**Michigan Department of Environmental Quality (DEQ) Review Comments on the Tittabawassee River Segment 4 and 5 (OU1) Draft Response Proposal – Revision 0
Settlement Agreement No. V-W-10-C-942 for the Tittabawassee River/Saginaw River & Bay Site
Dow Submittal Number: 2015.057**

March 11, 2016

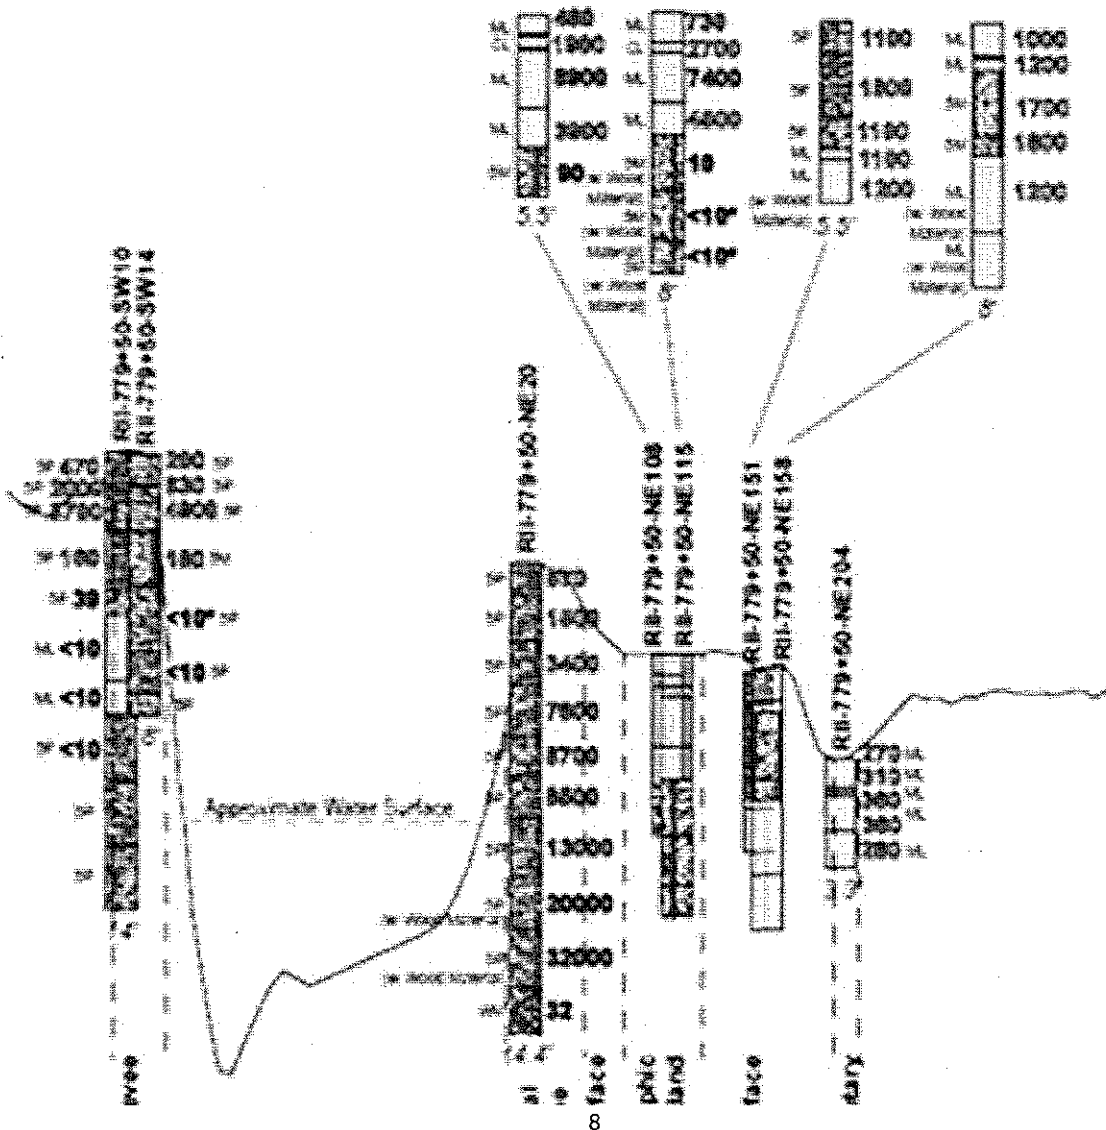
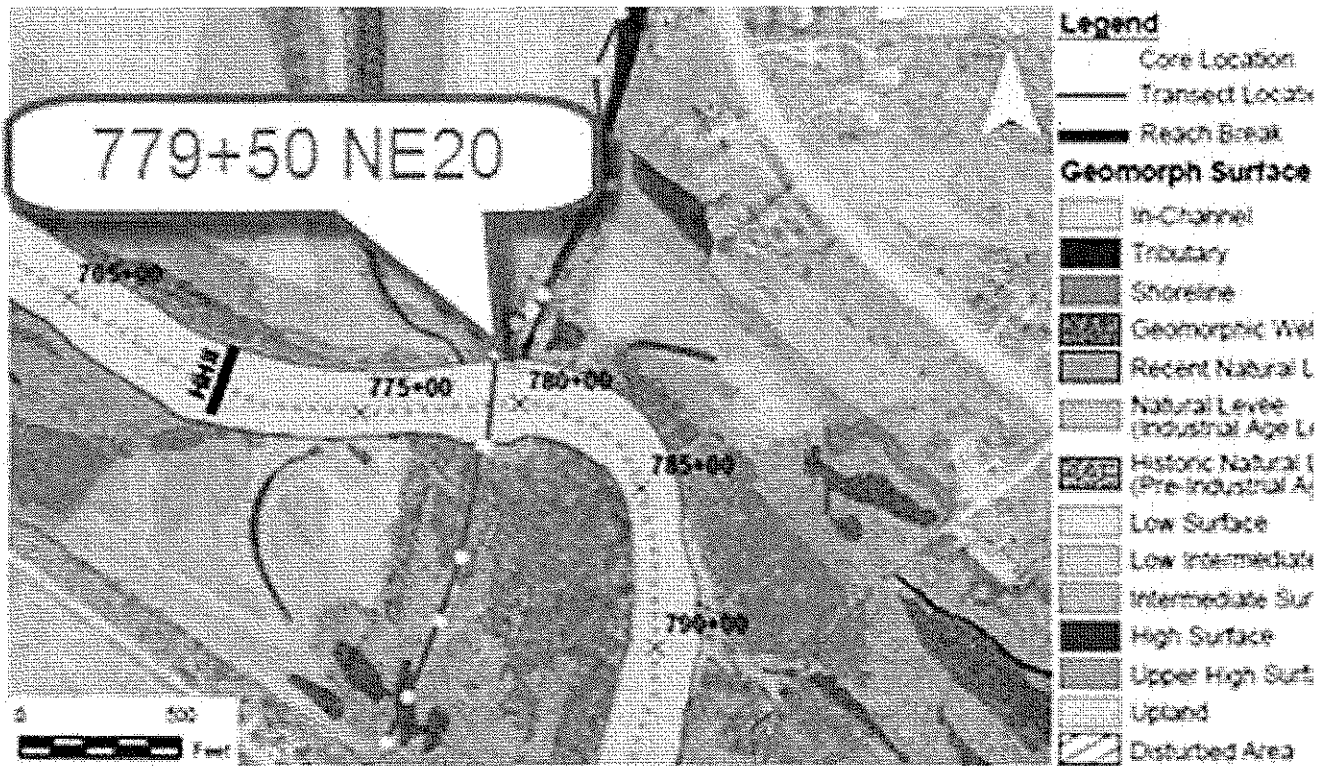
- ii. Bed pin transect 783+00, which is squarely within the proposed SMA, shows up to 4.2 feet of change in bed depth at and proximal to the proposed SMA. The bed depth in this area is quite active and this needs to be considered in the evaluation of remedial alternatives for this SMA.

- c. Likewise, the description of bed stability in upper KK indicates that the deposit is located 1 foot below the sediment surface. Bed pin analysis in this area shows over 1 foot of change in bed elevation over the period when measurements have been taken. The active bed appears to impinge on the deposit.
